Access Compliance Report Public Rights-of-Way (Curb Ramps)

Main Street: OAK_KNOLL_DR Cross Street: ARGYLE_DR Location: NW

ADA ID: RPAT211206132519 Ramp Type: Type 1 - Perpendicular Diagonal Initial Pass/Fail: Pass Overall Compliance: No Severity Score: 21

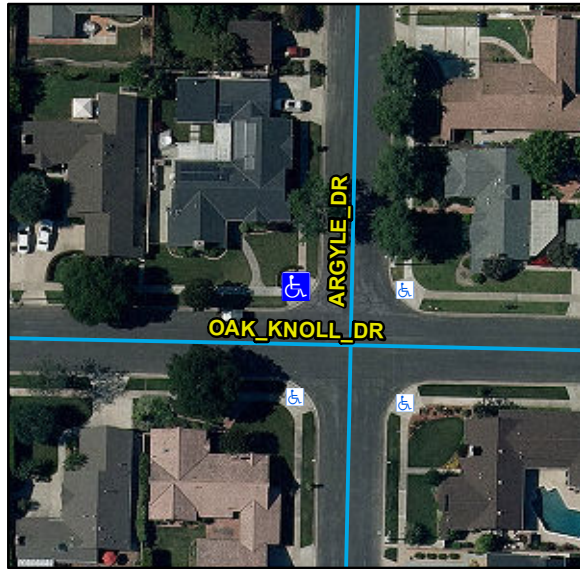
R304.2.2, R204.3, R304.2.1, R304.2.2-Perp, R304.3.2-Para, R305, R304.5.4, STD 1115

Compliance	Description	Data	Compliance	Description	Data
N/A	Ramp Length (in)	79	N/A	Flare Type LT	
Yes	Ramp Width (in)	48			Sloped
Yes	Ramp Run Slope (%)	6.8	N/A	Flare Slope LT (%)	6.8
Yes	Ramp Cross Slope (%)	0.8	N/A	Flare Traversable LT	No
N/A	Landing Present	Yes	N/A	Flare Type RT	
N/A	Landing Length (in)	37			Sloped
Yes	Landing Width (in)	58	N/A	Flare Slope RT (%)	7.5
No	Landing Run Slope (%)	2.3	N/A	Flare Traversable RT	No
Yes	Landing Cross Slope (%)	0.6	No	DWS Provided	No
N/A	Landing Movement Obstructed?	No	N/A	DWS Contrast	N/A
	Landing Movement Type	N/A	N/A	DWS Length (in)	N/A
N/A	Landing Shared	No	N/A	DWS Full Width	N/A
N/A	Clear Space	Yes	N/A	DWS Offset Left (in)	N/A
N/A	Clear Space To Crosswalk (in)	48	N/A	DWS Offset Right (in)	N/A
N/A	Marked Crosswalk 1	No	N/A	Marked Crosswalk 2	No
	Crossing 1 Direction	S		Crossing 2 Direction	E
	Marked Crosswalk 1 Width (in)	N/A		Marked Crosswalk 2 Width (in)	N/A

N/A	Ramp Inside Crosswalk 1	N/A	Yes	Ramp Inside Crosswalk 2	N/A
	Crossing 1 Slope (%)	5.8		Crossing 2 Slope (%)	4.8
	Crossing 1 Cross Slope (%)	1.4		Crossing 2 Cross Slope (%)	1.9
Yes	Gutter Ponding	No	No	Curb Slope	8.8
Yes	Gutter Lip Height (in)	0		Road Run Slope (%)	0.3
No	Gutter Run Slope (%)	6.1		Road Cross Slope (%)	5.5
Yes	Gutter Cross Slope (%)	0.1			
Yes	Overall Surface Condition: Acceptable		No	Perp Joint Present	No
	Cross Gutter Present?	No		Spandrel Present?	No
	Replace Cross Gutter?	N/A		Replace Spandrel?	N/A

Remove & Replace Curb Ramp With Two New Directional Ramps or Equivalent. Remove & Replace Gutter.
